UNITED STATES PATENT AND TRADEMARK OFFICE

APPLICATION NO.	FILING DATE	FIRST NAMED INVENTOR	ATTORNEY DOCKET NO.	CONFIRMATION NO.
10/600,479	06/19/2003	Seiya Asano	3702/0M969US0	6321

Office Action Summary

DETAILED ACTION

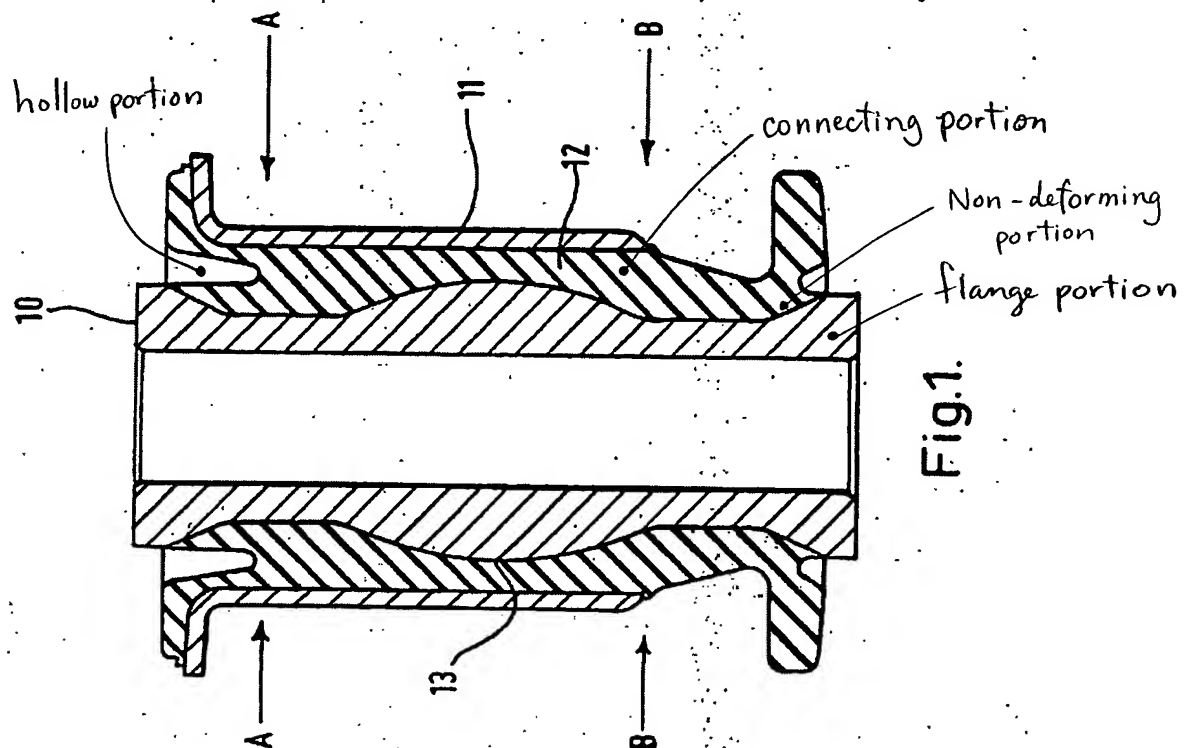
Re: claim 1, Nicholson shows a vibration isolating bushing in figure 1, as in the present invention, comprising: a main shaft member 10 including a tubular portion, a flange portion, as marked below, extending radially outwardly from one end of the tubular portion, and a block portion 13 provided on a central portion of the tubular portion and distanced from the flange portion in an axial direction of the main shaft member; an outer cylinder member 11 disposed coaxially on an outer side of the main shaft member in a distance therefrom; and a rubber elastic body 12 disposed between the main shaft member and the outer cylinder member integral connection of the main shaft member and the outer cylinder member, said rubber elastic body including a hollow portion, as marked below, which is open in an end face away from the flange portion and extends in the axial direction up to the vicinity of an end face on a side the flange portion; wherein the rubber elastic body further includes non-deforming rubber portion, please see the figure below, and a connecting portion, see the figure below; the non-deforming rubber portion fills a gap between the flange portion and an end face of the block portion facing the flange portion in the axial direction and is substantially

undeformable with respect to an application of an axial load; the connecting portion is positioned between a bottom the hollow portion and the end face of the rubber elastic body on the side of the flange portion, for connecting the non-deforming rubber portion and an inner peripheral surface of an end portion of the outer cylinder member.

Re: claim 2, Nicholson shows the block portion 13 radially outwardly protruding end face as claimed.

Re: claim 3, Nicholson further shows the connecting portion to be offset inwardly compared to the non-deforming portion.
